From: Buttery, Lucy
Sent: 01 April 2020 11:12
To: _planningadvice
Subject: FW: Document issue No 9 - 19-0305 : Civil - Low Road, Crowland, Peterborough, Residential Development
Attachments: ZippedAttachments.zip

19-0305 : Civil - Low Road, Crowland, Peterborough, Residential Development Issue 9

19-0305 - LOW ROAD, CROWLAND, PETERBOROUGH

Please find below our response to the LLFA queries received 27th November 2019.

Watercourse Capacity Check
Catchment Area

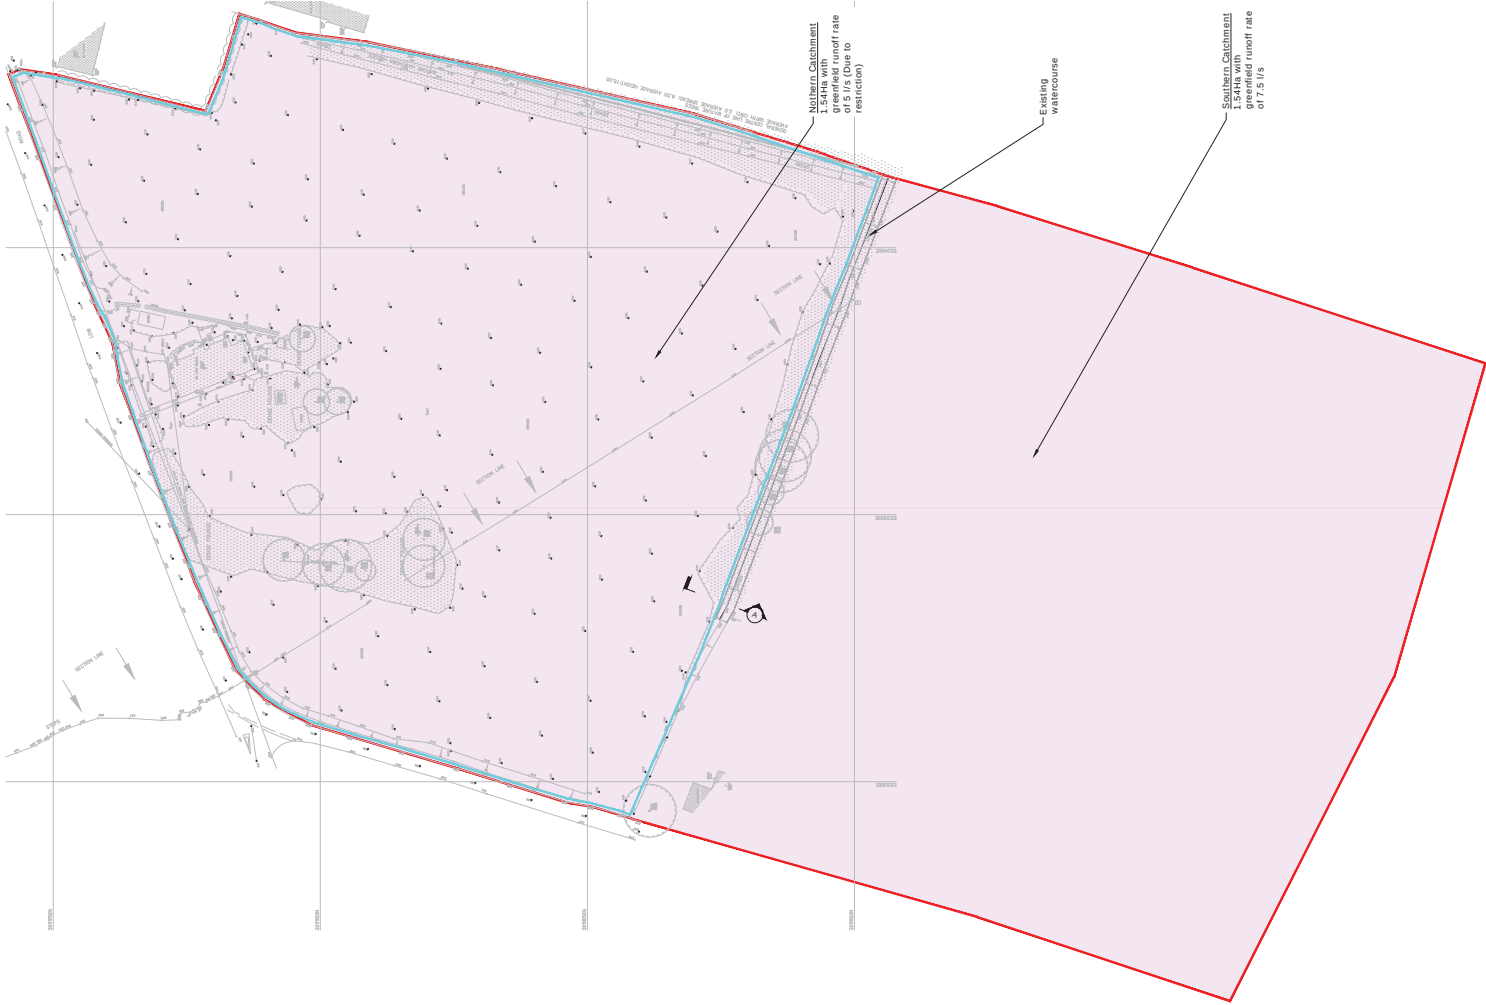
3. *Can the Applicant/Agent be asked to provide evidence that the watercourse on the south side of the site, into which the site surface water drainage system is proposed to be discharged, has the capacity and a suitable hydraulic gradient to convey the surface water to the point of discharge into the IDB maintained system. I had a look at the watercourse yesterday and it looked shallow and overgrown. It runs between land that does not appear to be in the control of the Applicants so I am not sure what rights the Applicants would have to undertake any improvement work.*

The watercourse to the southern side of the site has been modelled to check its capacity, refer to enclosed drawing (190305-RGL-ZZ-XX-DR-D-121-0001) for details. The existing catchment area for the watercourse at the southern boundary of the site is approximately 3.08Ha and the existing peak greenfield runoff rate has been determined as 15 l/s for the 1 in 100 year return period event. (refer to enclosed calculations). The northern section of the catchment area that forms the development site is restricting the flow to 5 l/s maximum and the lower section (at Greenfield run-off) would be 7.5 l/s. Therefore, the peak flow would be 12.5 l/s following development.

The watercourse has been modelled for a variety of roughness coefficients to reflect lack of maintenance and to determine the percentage utilisation and therefore available capacity to accommodate the scheme. - refer to the table below for remaining capacities and enclosed calculations for the worst-case roughness value.

ROUGHNESS COEFFICIENT (N)	WATERCOURSE DESCRIPTION	CAPACITY (L/S)
0.025	Good condition	280.4
0.035	With stones and weeds	200.3
0.06	Very poor	116.8

Based on the above capacities the channel flow utilisation is approximately 10% of the capacity and therefore provides a large factor of safety against future maintenance and the capacity of the downstream section of watercourse prior to the outfall to the IDB drain.
